# Access Compliance Report

## Public Rights-of-Way

Intersection ID: 11933	Main Street: N_TRYON_ST	Cross Street: E_8TH_ST	Location: N
ADA ID: B992ADFEA14F	Ramp Type: PerpDiag	Initial Pass/Fail: Fail	Overall Compliance: No
Severity Score: 12.5			
Codes/Mitigation Info/Possible Solution		Field Measurements/Component Compliance

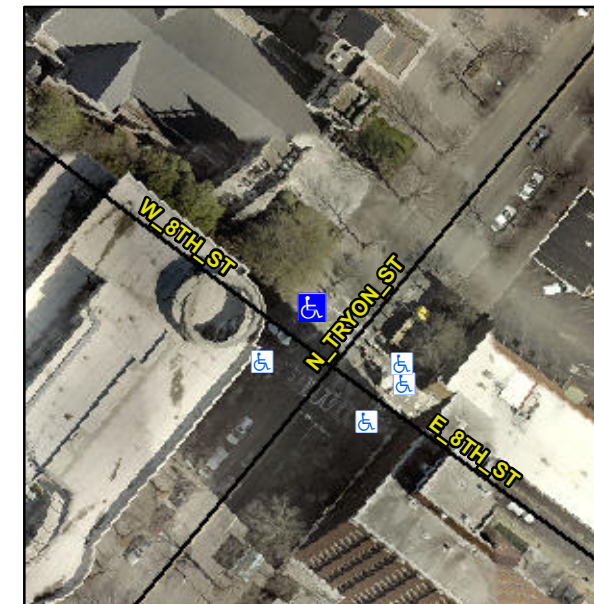
**Remove & Replace Curb Ramp With Two New Directional Ramps or Equivalent.**

**R304.2.2**

Compliance	Description	Data	Compliance	Description	Data
N/A	Ramp Length (in)	87.0	No	Ramp Slope (%)	9.5
Yes	Ramp Width (in)	48.0	Yes	Ramp XSlope (%)	2.0
N/A	Flare Type LT	N/A	N/A	Flare Type RT	N/A
N/A	Flare Slope LT (%)	N/A	N/A	Flare Slope RT (%)	N/A
N/A	Flare Traversable LT?	N/A	N/A	Flare Traversable RT?	N/A
N/A	Landing Length (in)	N/A	N/A	DWS Provided?	N/A
N/A	Landing Width (in)	N/A	N/A	DWS Contrast?	N/A
N/A	Landing Slope (%)	N/A	N/A	DWS Length (in)	N/A
N/A	Landing X Slope (%)	N/A	N/A	DWS Full Width?	N/A
N/A	Landing Curb? (Y/N)	N/A	N/A	DWS Offset (in)	N/A
N/A	Shared Landing?	N/A			
N/A	Gutter Ponding?	N/A	N/A	Gutter Slope (%)	N/A
N/A	Gutter Lip Ht (in)	N/A	N/A	Gutter X Slope (%)	N/A
N/A	Painted X Walk1?	Yes	N/A	Painted X Walk2?	Yes
	X Walk 1 Direction	To SW		X Walk 2 Direction	To SE
N/A	X Walk 1 Width (in)	108.0	N/A	X Walk 2 Width (in)	105.0
	X Walk 1 Slope (%)	3.7		X Walk 2 Slope (%)	3.7
	X Walk 1 X Slope (%)	0.0		X Walk 2 X Slope (%)	5.1
